Roads & Street Standards Exception Application

Subject: Envy Winery located at 1170 Tubbs Ln, Calistoga, CA 94515 APN: 017-210-027 Road Exception Request for Commercial Driveway

Envy Wines #P18-00071 APN: 017-210-027

Sta O+50, Looking from Tubbs Lane

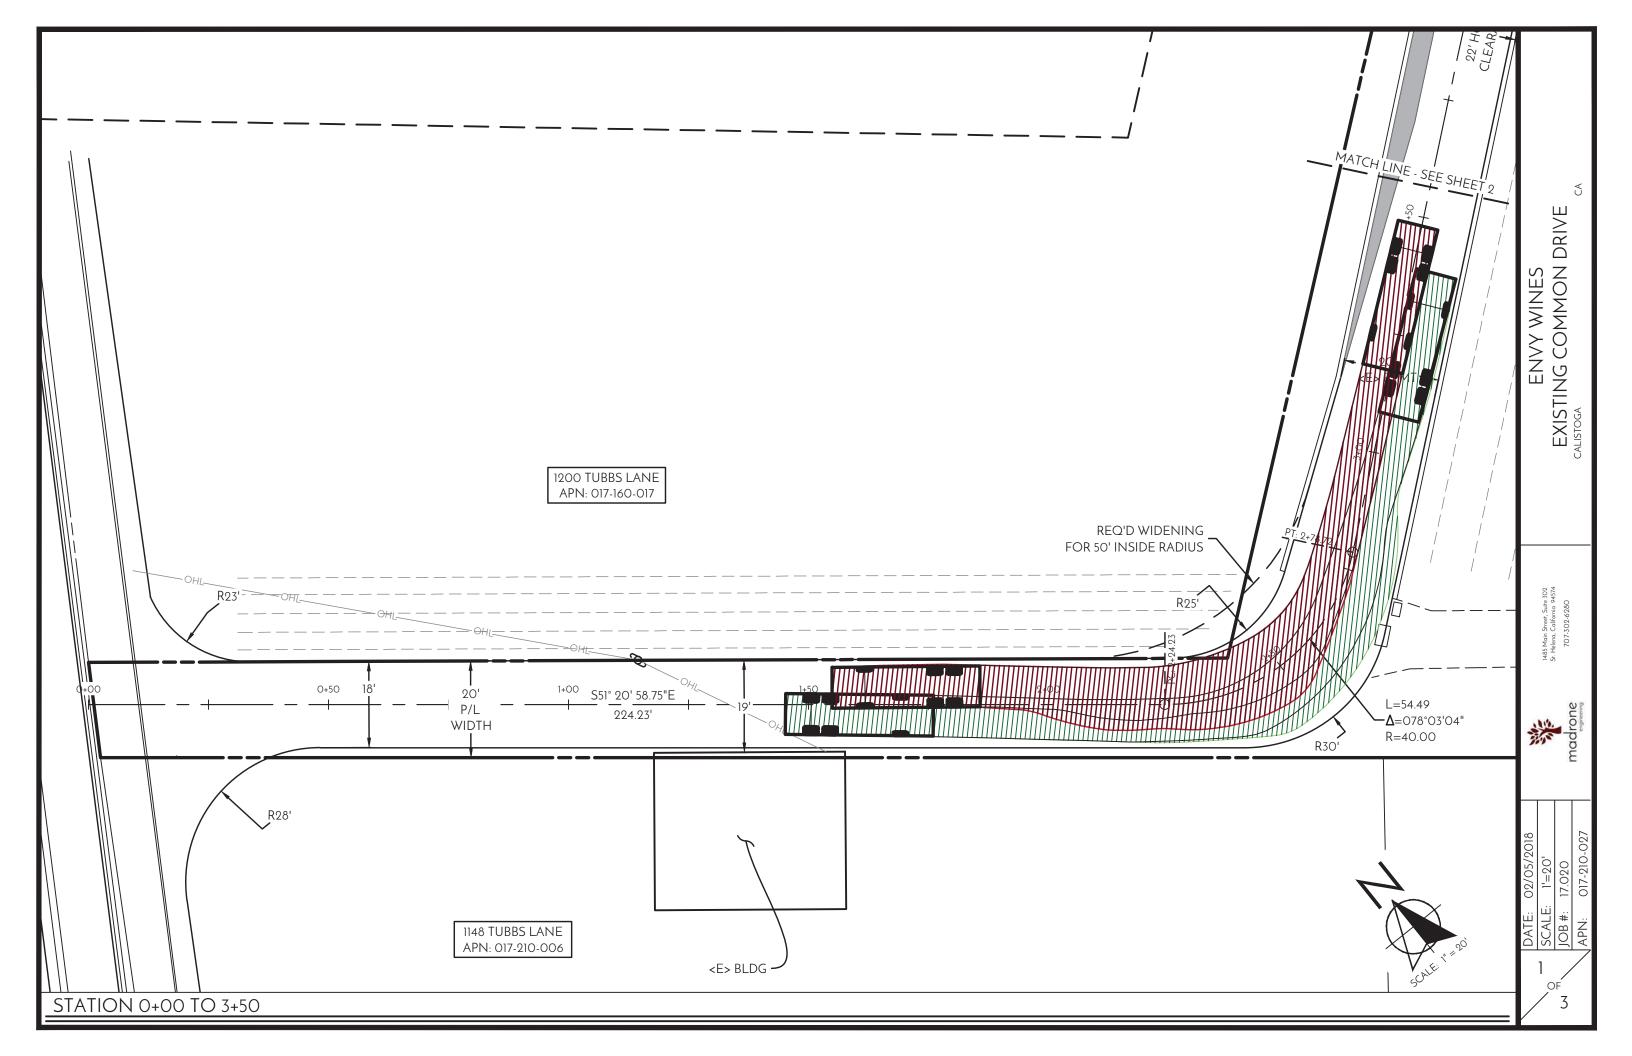
Location #1, Station O+50 to 2+50

Road Exception Request for common driveway width (see Sheet 1)

The driveway width at this location is 18 feet of pavement plus a gravel shoulder; however, widening the driveway to 20 feet of pavement at this location would require demolition of an existing structure outside the legal parcel boundary as it is located on a neighboring parcel and is bordered by a power pole and overhead lines serving that parcel. Because this portion of the road is straight, is 200 feet in length, and does not have a profile grade, sight distance is extremely good. There will be no impediments for safe access for emergency vehicles, safe civilian evacuation, and avoidance of delays in emergency response and the findings for the LRA request can be easily met. Please refer to the photo shown below for more information.

Sta 2+50, looking up station

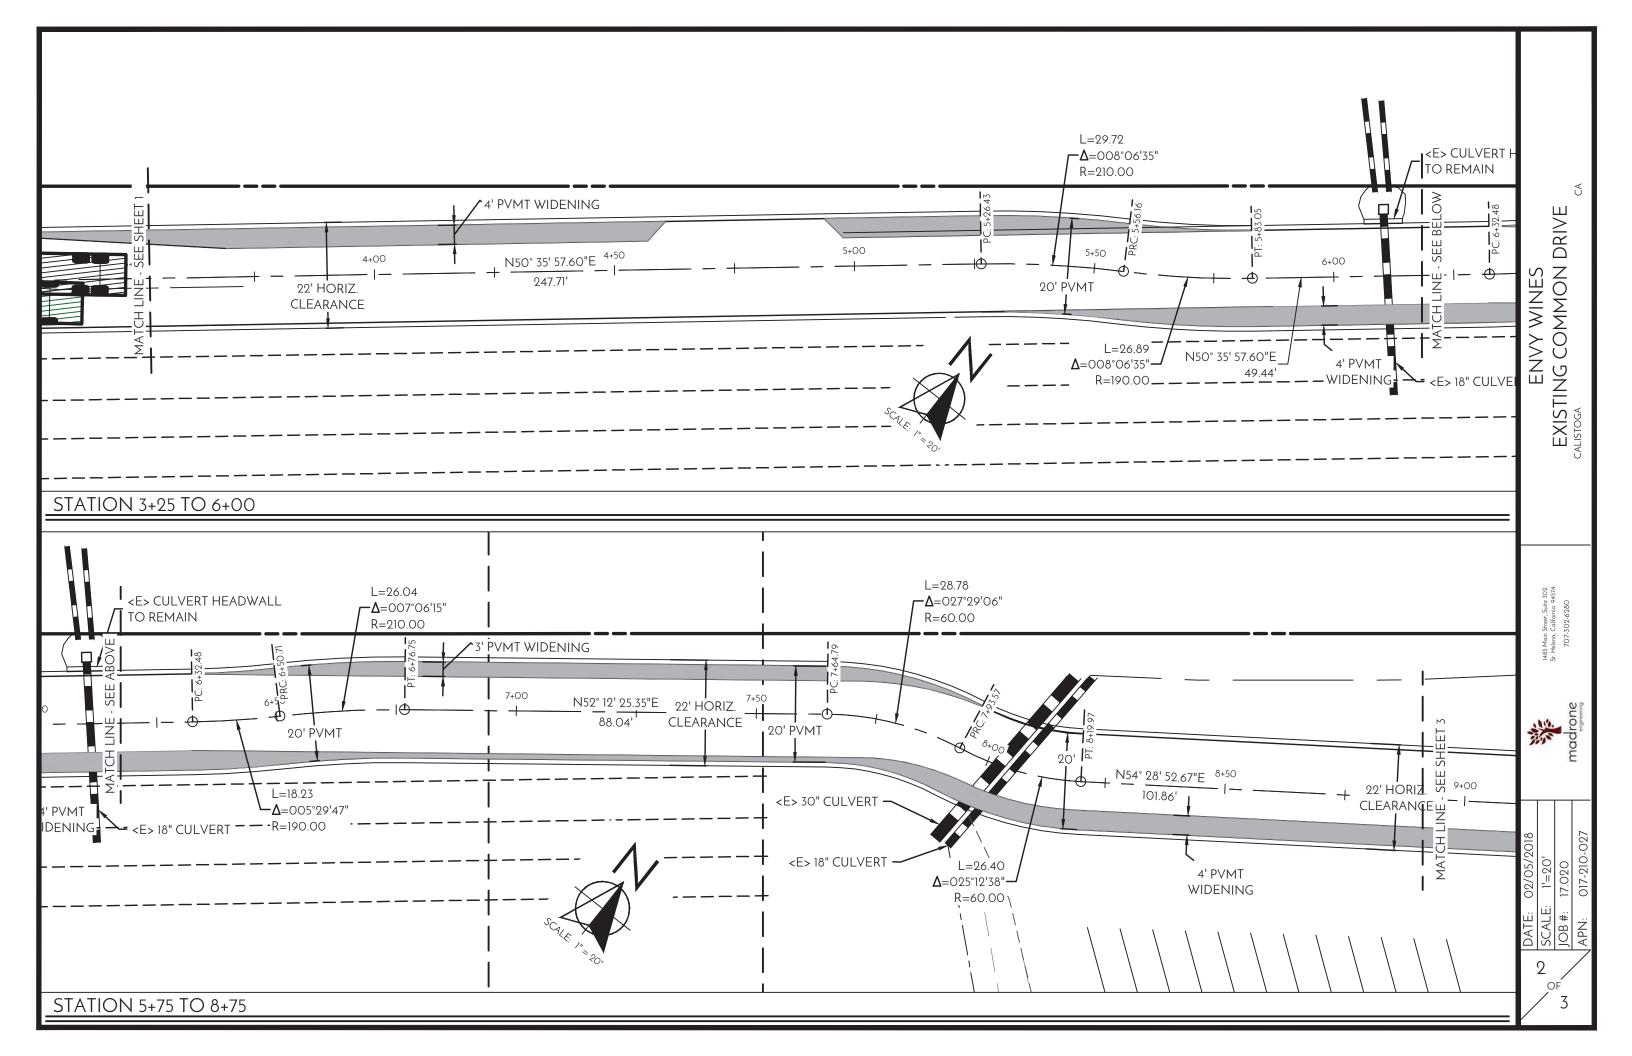
Location #2, Station 2+50

Road Exception Request for Horizontal Inside Radius (see Sheet 1)

In this area, the road includes a horizontal curve with centerline radius of 40 feet, and inside radius of 25 feet. Reconstructing the road to have a minimum inside radius of 50 feet is not possible as it would require construction outside the legal parcel boundary on a neighboring parcel. However, the road in this location is 25 feet wide, significantly wider than the minimum standard width, and we simulated a Napa County Fire Truck navigating the turn in each direction and can show that it is feasible for a fire truck to safely complete the turn; therefore in the event of an emergency there will be safe access, safe civil evacuation, and no delays in emergency response by granting this exception. All of the conditions for an LRA exception can be met. Please see the photo shown below for more information.
